SOUTHERN CALIFORNIA EDISON
KERN RIVER NO. 3 HYDROPROJECT

DOCKET NO. P-2290-122

KERN RIVER BOATERS' COMMENTS, STUDY
REQUESTS, AND INFORMATION REQUESTS IN
RESPONSE TO SCOPING DOCUMENT TWO AND
THE APPLICANT'S PROPOSED STUDY PLAN

Figure 2: Targeted Flows below Fairview Dam (May 21 & 22)

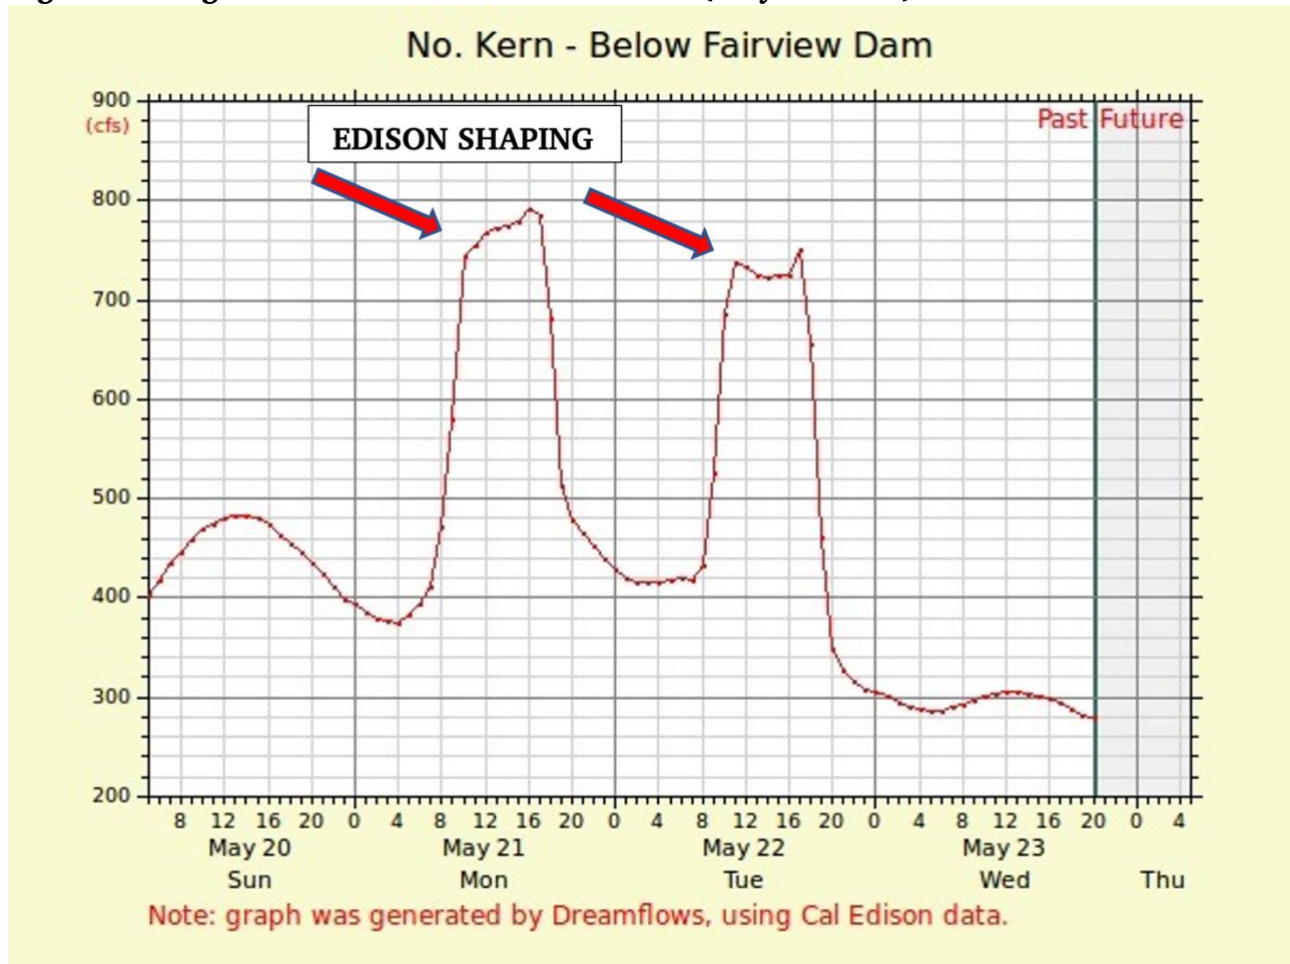
As can be seen above, flows above Fairview Dam between 10 a.m. and 5 p.m. on May 21 were between 1,000 and 1,100 cfs. Edison was able to shape the flows below Fairview and keep them at about 775 cfs (760-790). On May 22, incoming flows were 980 to 1,070 cfs, and Edison shaped flows below the dam at about 730 cfs (720-740).

The fact that Edison can shape flows below Fairview anywhere between the level of incoming flow to a level 600 cfs below that figure means there is a vast inventory of days upon which different flow levels could be tested in the dewatered reach. KRB took the daily average flow data from the last 25 years¹³⁶ and found the following average numbers of days upon which different flow levels could be tested annually:

Figure 2: Comparing Natural Flow and Current Conditions of NF Kern. Box plots show whiskers from 10th - 90th percentile as well as median values. 25th/75th percentile box lines interpolated from available data.

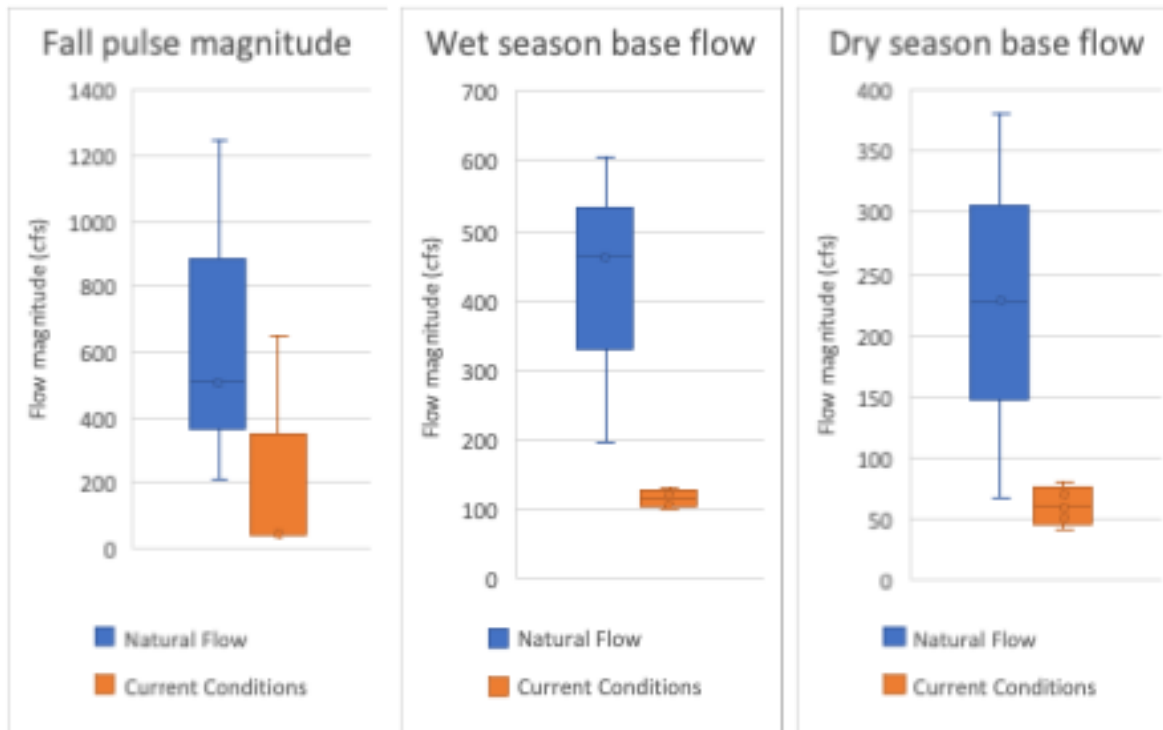
Comparing between the natural flow regime and the current MIF regime, it can be seen that the fall pulse flow, wet-season baseflow, and dry-season baseflow are significantly different and therefore likely altered from what a natural flow regime would be. This can also be seen graphically in Fig. 2.

The failure to provide three of these fine functional flow components in the current MIF regime means that key ecosystem functions and overall ecosystem health are not being supported.

Figure 3: Comparing the Current MIF regime with the modern environmental standards in California

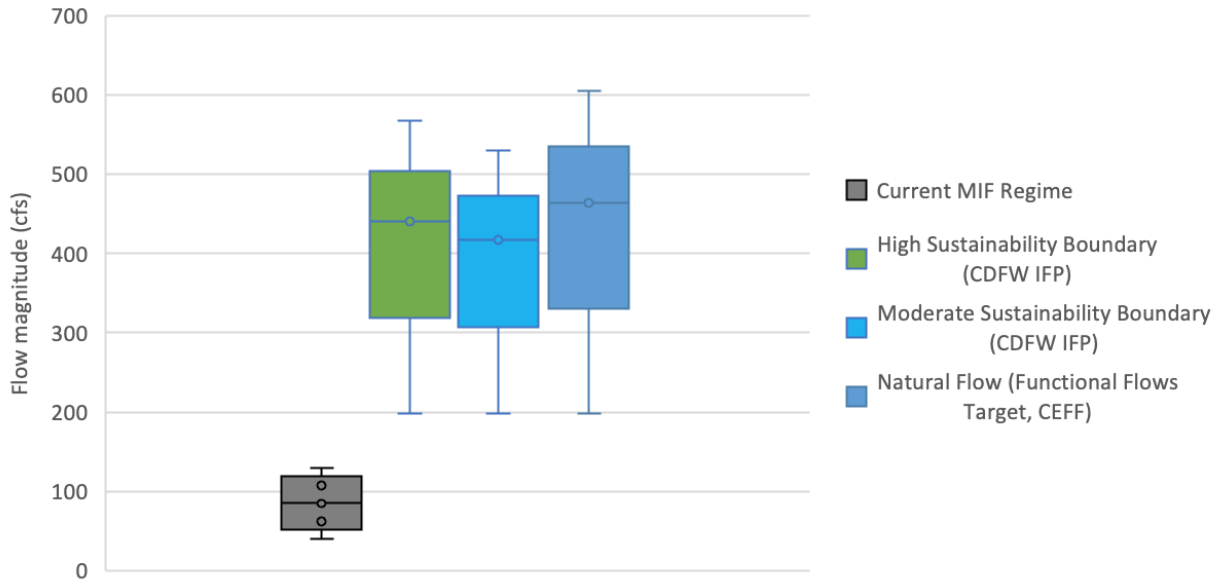
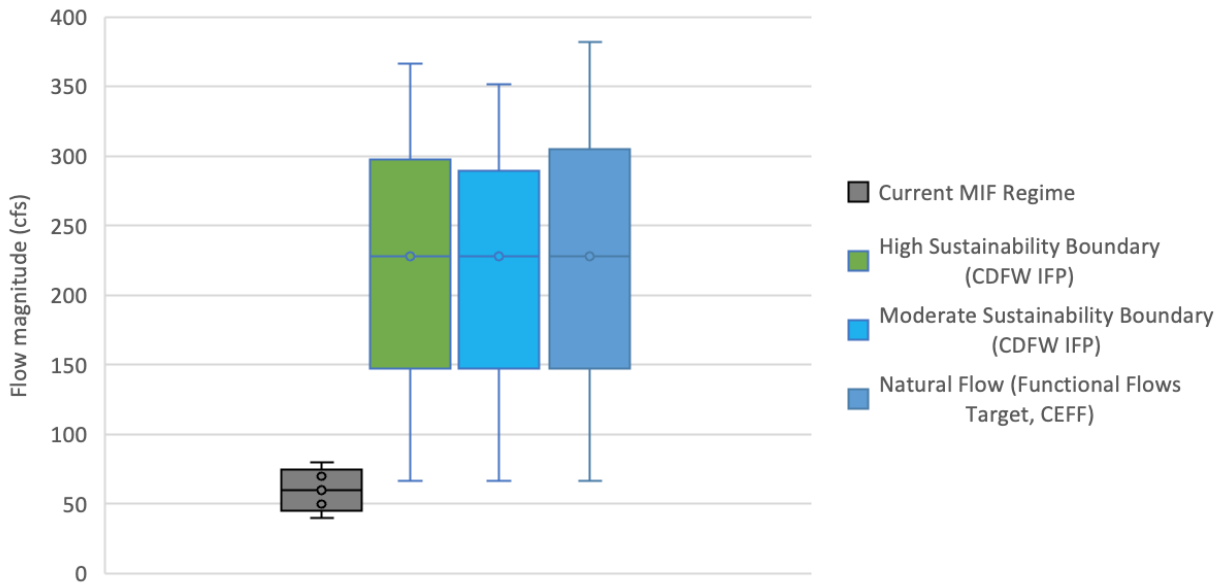
For example, as one means of implementation, the CDFW provides low flow threshold and percentage take calculation criteria via the Sustainability Boundary methods (CDFW, 2017; Duxbury, 2022). Comparing the current MIF regime with the recommendations provided by either the CDFW or the CEFF, it can be seen that current modern environmental recommendations in California are broadly in agreement, and the current MIF regime is significantly out of sync with all recommendations (Fig 3).

This preliminary analysis suggests that there is a significant discrepancy in these functional flow components between current conditions in the dewatered stretch of the NF Kern and scientifically recommended environmental flows. Therefore, conducting a full analysis per the CEFF, including full analysis by water year type (Wet, Moderate, Dry) as indicated by the framework would provide a full set of environmental flow criteria to be considered as a part of the relicensing.
